# ETC® Release Note

## Eos®/ Ion™ Lighting Control Family Software

Version 1.4.2 software

500004392

### Key-Cap Update

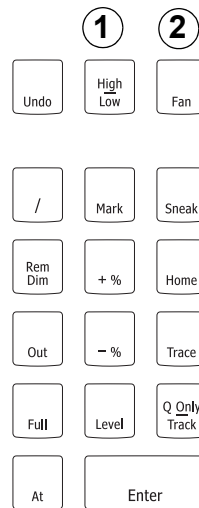
From Eos v1.3.1 to v1.4.x, two keys have been re-mapped and require that you change the physical keys on the console keyboard to match the software.

- "High/Low" replaces "Relate" and "Fan" replaces the blank key.

Step 1: Use the key puller provided to remove the two keys shown below in the order indicated below.

Step 2: Place the keys in their new correct locations and press them down firmly.

Below is the correct orientation to use the key puller for these keys.  
Remove "Relate" and the adjacent blank key.

Remove the keys in the order shown by the numbers next to each location.
